# SQUARE 487

COMMISSION OF FINE ARTS | CONCEPT REVIEW | 20 MAY 2021

SECOND SUBMISSION | FIRST REVIEW: 18 MARCH 2021

ROCKEFELLER GROUP | STONEBRIDGE

# Massing Comparison

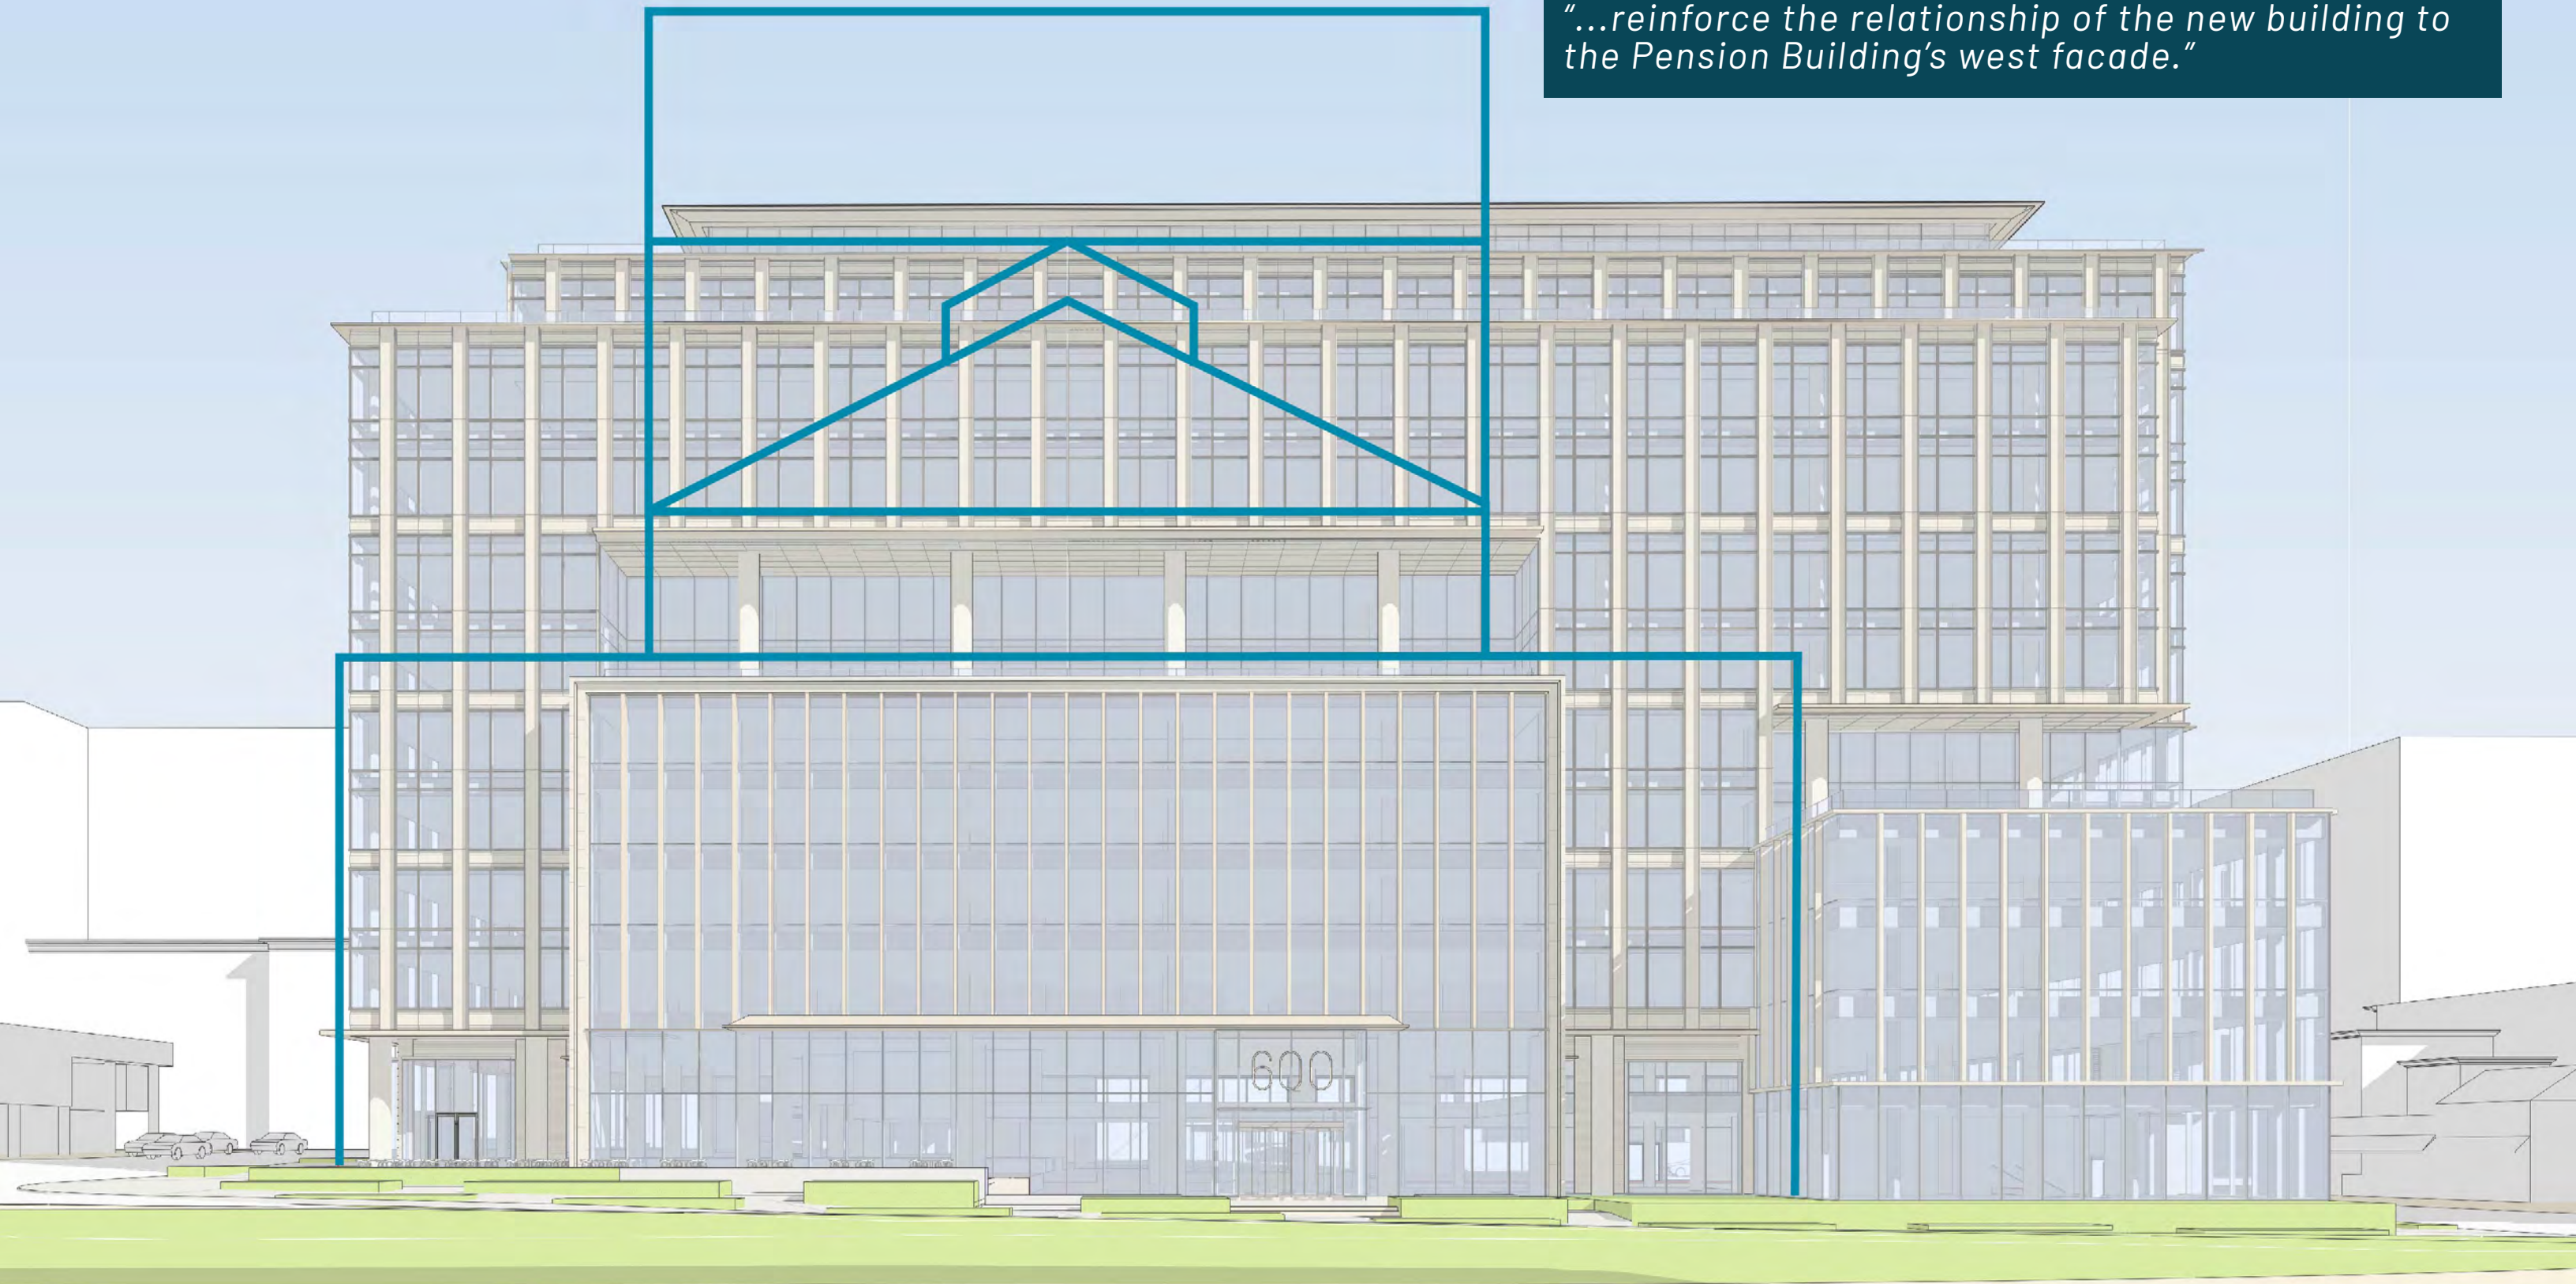
**CFA Comment:**

*"...reinforce the relationship of the new building to the Pension Building's west facade."*

**Building Massing**  
Pension Building Symmetry

**Relationship to Pension Building**

**Building Massing**  
Enclosure Simplification

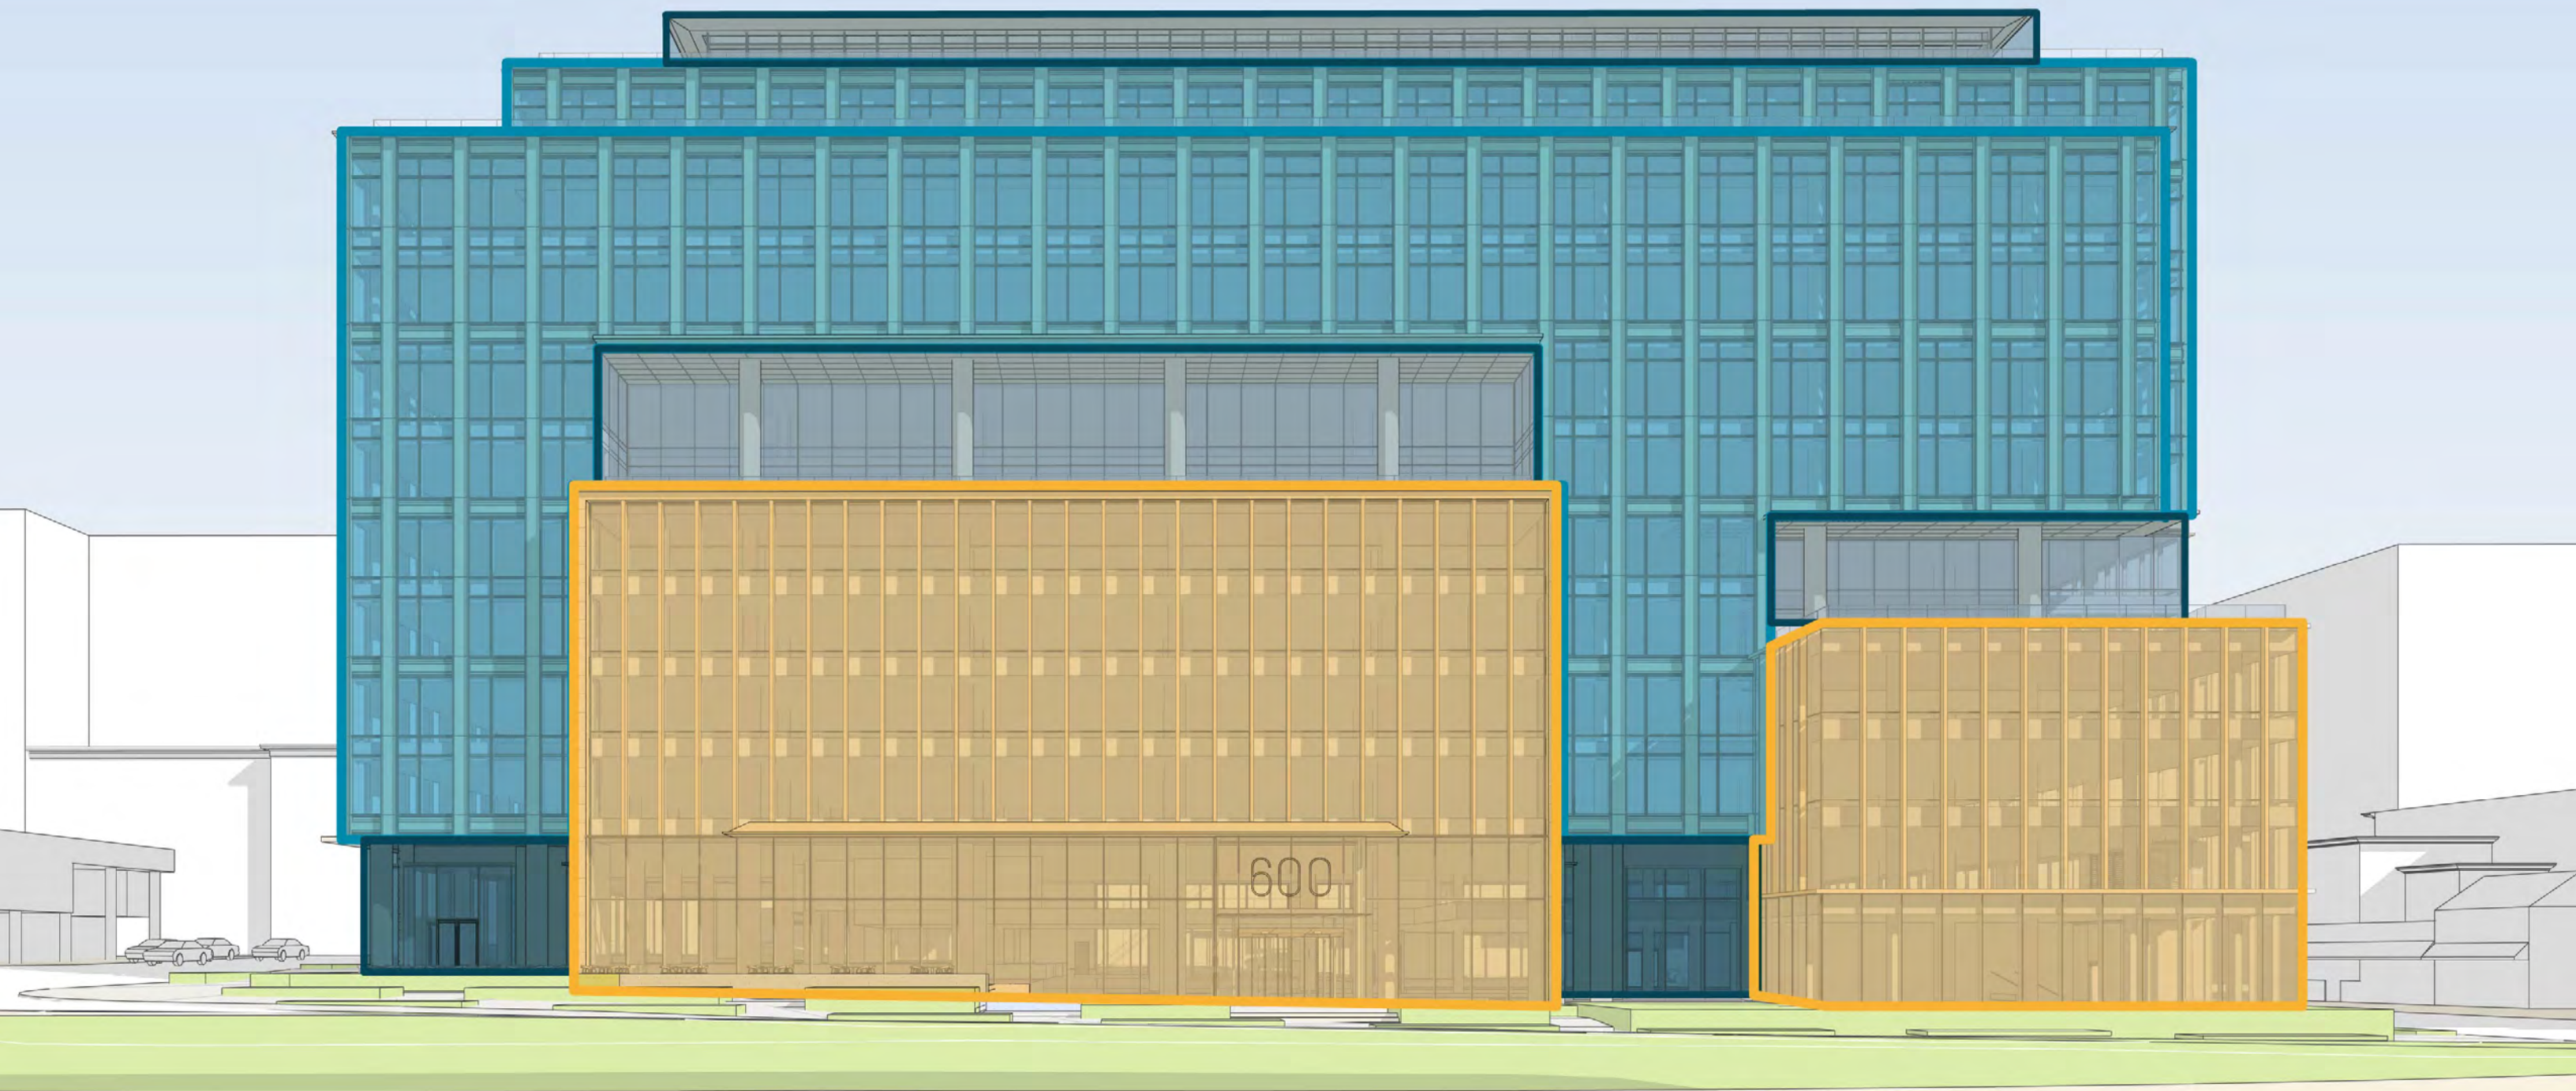
Number of Enclosure Types  
CFA Comment:  
*"...recommended a simplification of enclosure types."*
